Our ref: SDB/ST20570/01
 Your ref: CONS/2024/0070

Proposed development at land off Halterworth Lane, Romsey, Hants

I refer to your consultation response ref CONS/2024/0070 to Test Valley Borough Council dated 5th February 2024, which has been forwarded to my client Gladman Developments Ltd. That response document related to a Mineral Resource Assessment which had been prepared by me and submitted to Test Valley BC by our client. Your letter raised a number of points regarding omissions of data and I am now in a position to provide you with answers, as the relevant geological data were not available at the time we prepared the initial Mineral Resource Assessment. The supporting evidence has been integrated into the attached "Updated Mineral Resource Assessment March 2024" and I have set out below the paragraph numbers in the MRA where we have provided answers to the points you raised in your letter of the 5th February.

UPDATED MINERAL RESOURCE ASSESSMENT MARCH 2024.

Appendix 4
Groundwater Monitoring Graph

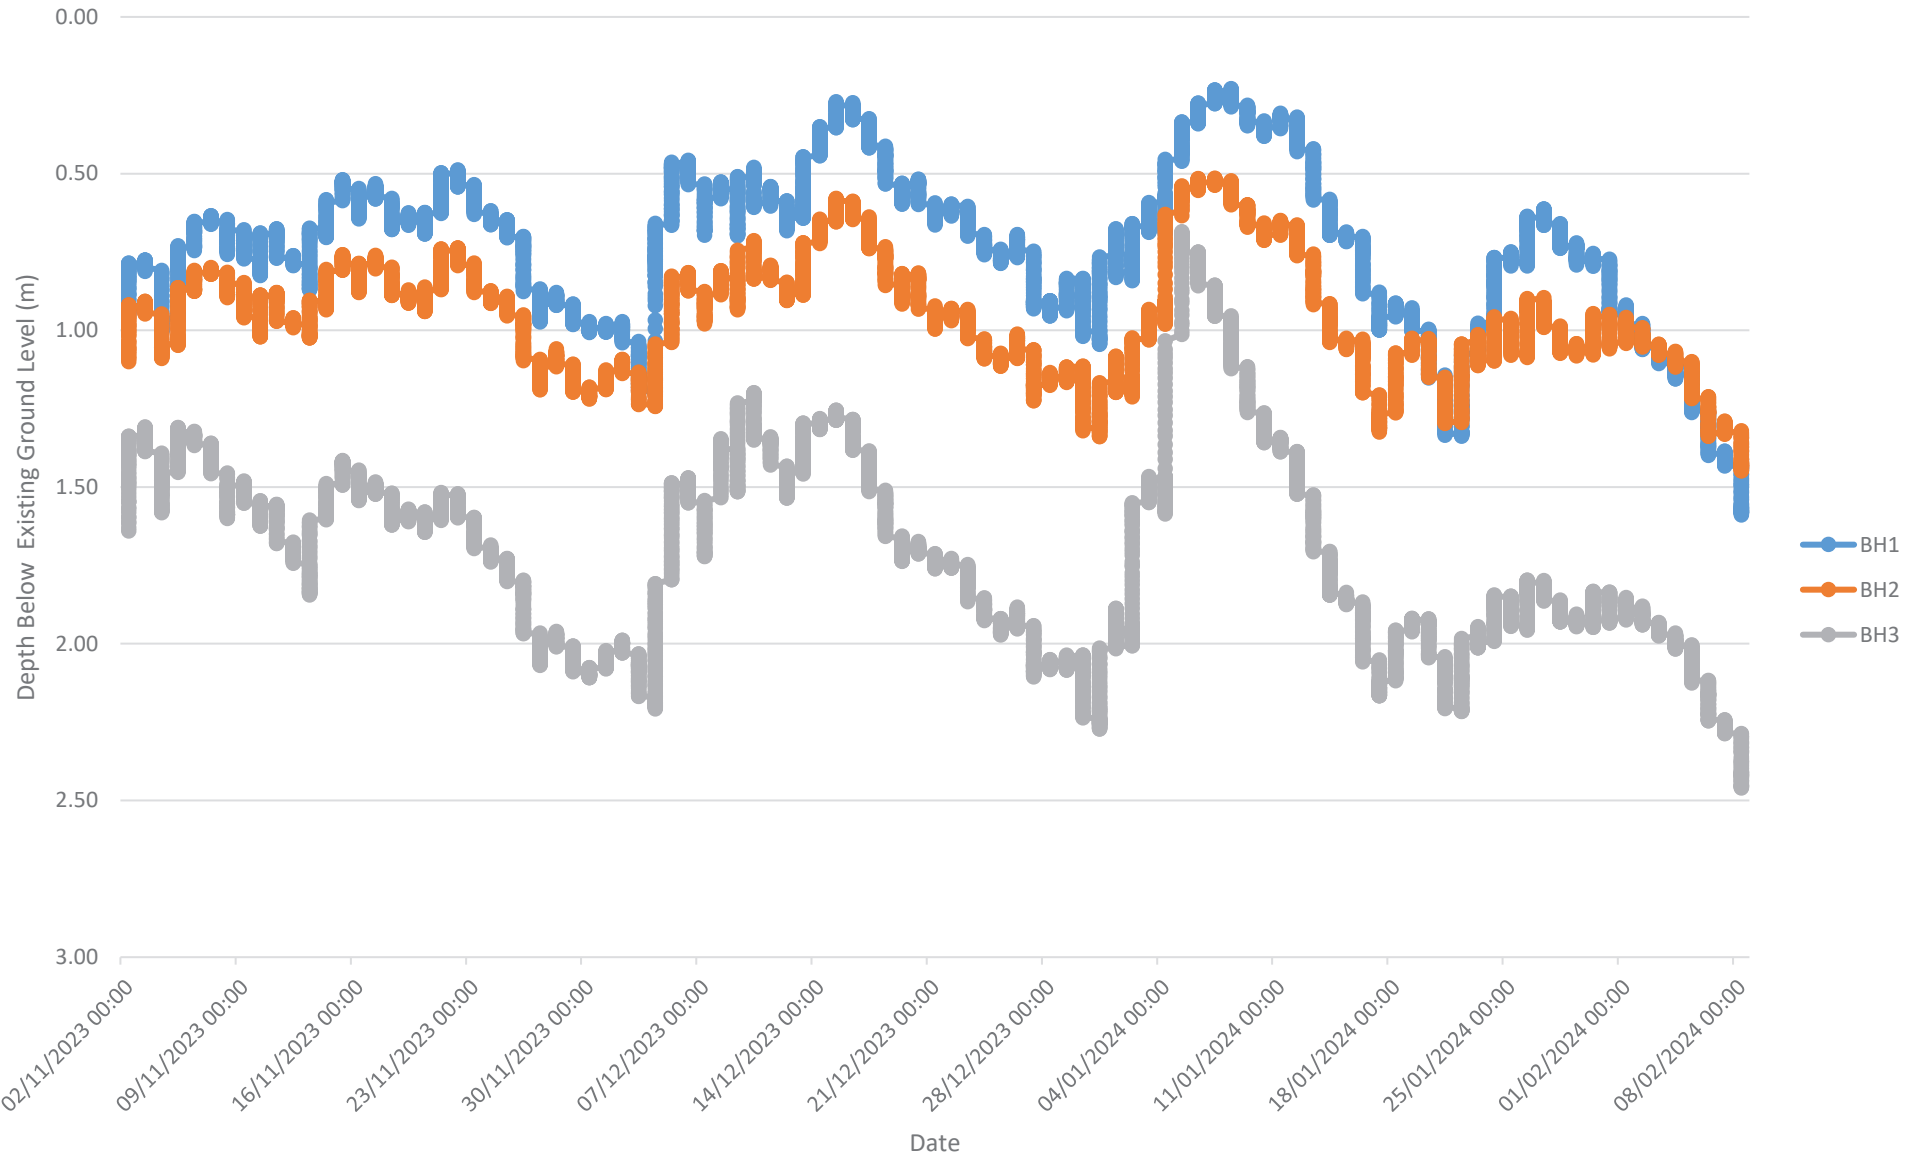
Lack of empirical geological data – the updated MRA Appendices 2, 3 and 4 contain empirical data in the form of logs of 9 trial pits and 3 boreholes constructed on the site together with records of groundwater levels in the 3 boreholes.

3.4.1 Groundwater level monitoring was undertaken in the 3 boreholes between November 2023 and February 2024. The results are shown on the attached graph of “Groundwater monitoring data” at Appendix 4. The monitoring data show that groundwater is present at approximately 1m below ground level (bgl) in boreholes 1 and 2 and at 1.5-2m bgl in borehole 3.
